SUBJECT: ISSUANCE OF AMENDMENT NO. 116 TO FACILITY OPERATING LICENSE NO. NPF-12 REGARDING INCREASED LIMIT FOR FUEL ENRICHMENT - VIRGIL C. SUMMER NUCLEAR STATION, UNIT NO. 1 (TAC NO. M88452)

VIRGIL C. SUMMER NUCLEAR STATION, UNIT NO. 1

AMENDMENT TO FACILITY OPERATING LICENSE

Amendment No. 116  
License No. NPF-12

**FIGURE 3.9-1 MINIMUM REQUIRED FUEL ASSEMBLY BURNUP AS A FUNCTION OF INITIAL ENRICHMENT TO PERMIT STORAGE IN REGION 2**

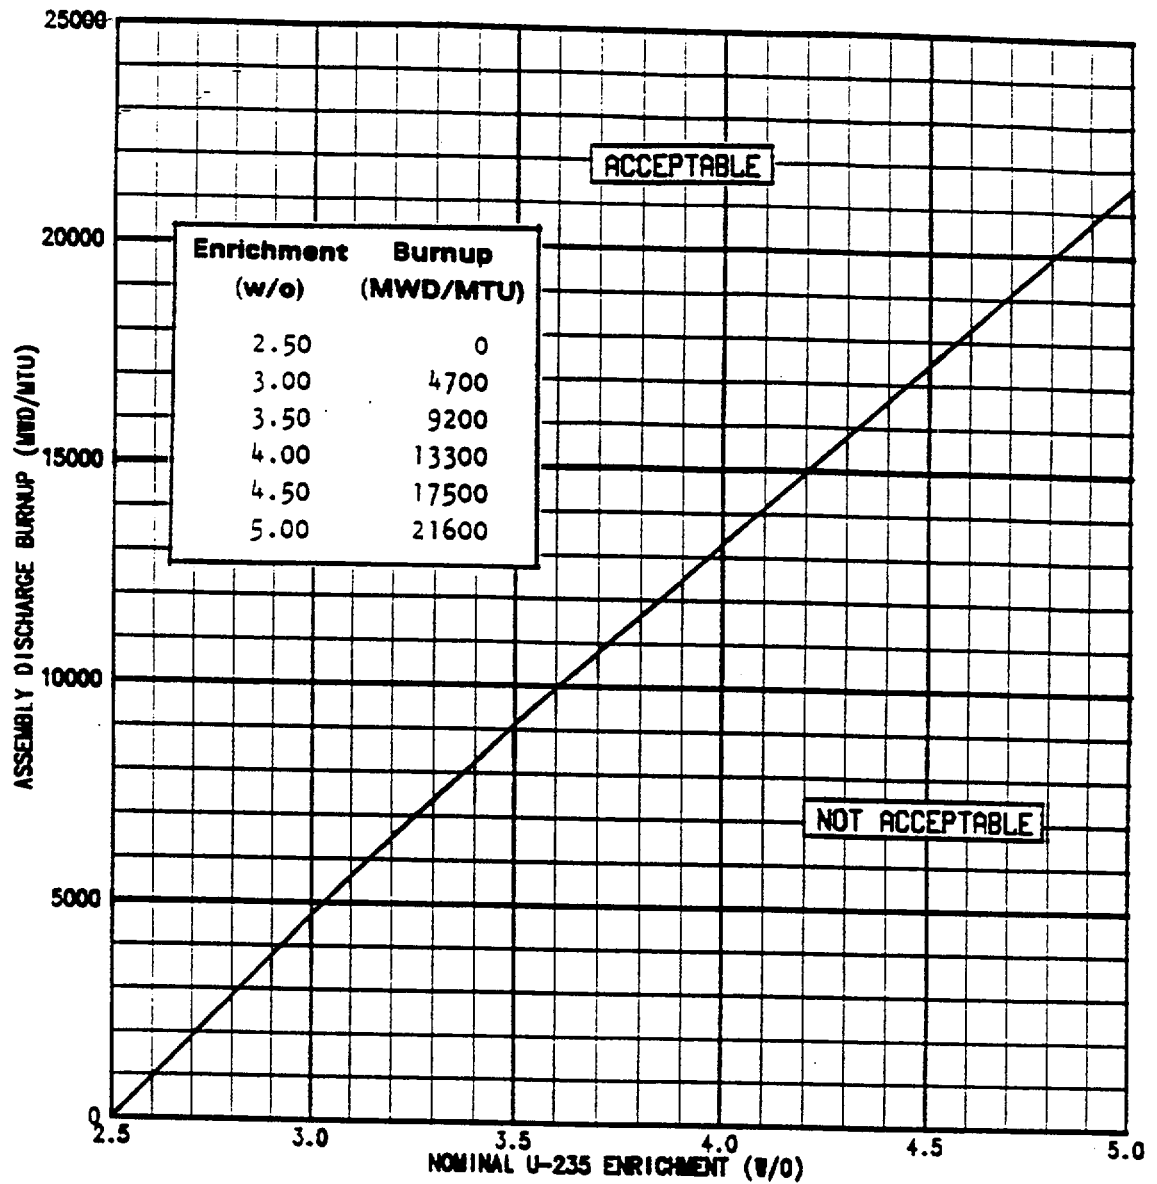
To enable the storage of fuel assemblies initially enriched to greater than 2.5 w/o U-235, the concept of burnup credit reactivity equivalencing was used. This is predicated upon the reactivity decrease associated with fuel depletion and has been previously accepted by the staff for spent fuel storage analysis. For burnup credit, a series of reactivity calculations are performed to generate a set of initial enrichment-fuel assembly discharge burnup ordered pairs which all yield an equivalent  $k_{\text{eff}}$  less than 0.95 when stored in the spent fuel storage racks. This is shown in Figure 3.9-1 in which a fresh 2.5 w/o enriched fuel assembly yields the same rack reactivity as an initially enriched 5.0 w/o assembly depleted to 21,600 MWD/MTU. This curve includes a reactivity uncertainty of 0.0072 due to depletion calculations.

- (1) Figure 3.9-1 has been revised to place restrictions on fuel burnup as a function of initial enrichment up to 5.0 w/o U-235 and to account for the effects of Boraflex panel shrinkage and gaps in Region 2 of the spent fuel pool.

2. A maximum nominal enrichment of 2.5 weight percent U-235 with no burnup and up to 5.0 weight percent U-235 with a minimum burnup of up to 21,600 MWD/MTU, as specified in Figure 3.9-1.

**FIGURE 3.9-2 MINIMUM REQUIRED FUEL ASSEMBLY BURNUP AS A FUNCTION OF INITIAL ENRICHMENT TO PERMIT STORAGE IN REGION 3**

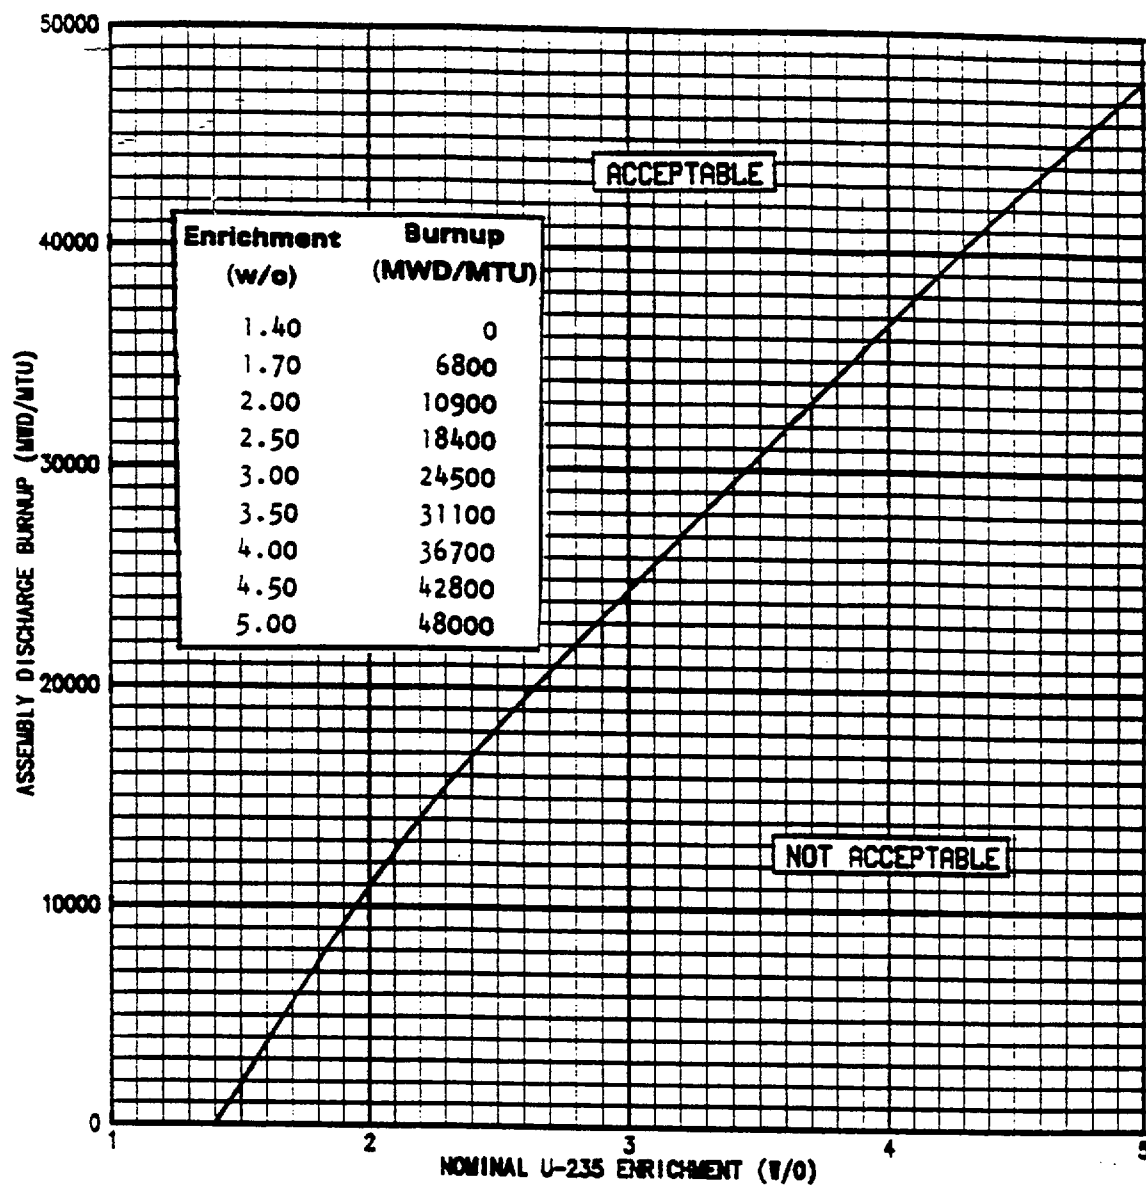
As for Region 2, burnup credit reactivity equivalencing was used to allow storage of fuel assemblies with initial enrichments greater than 1.4 w/o U-235. Figure 3.9-2 shows that fresh 1.4 w/o enriched fuel is equivalent to initially enriched 5.0 w/o fuel which has achieved a burnup of 48,000 MWD/MTU. The curve includes a reactivity uncertainty of 0.0160 due to depletion calculations.

- (2) Figure 3.9-2 has been revised to place restrictions on fuel burnup as a function of initial enrichment up to 5.0 w/o U-235 in Region 3 of the spent fuel pool. Region 3 does not contain Boraflex.

2. A maximum nominal enrichment of 1.4 weight percent U-235 with no burnup and up to 5.0 weight percent U-235 with a minimum burnup of up to 48,000 MWD/MTU, as specified in Figure 3.9-2.
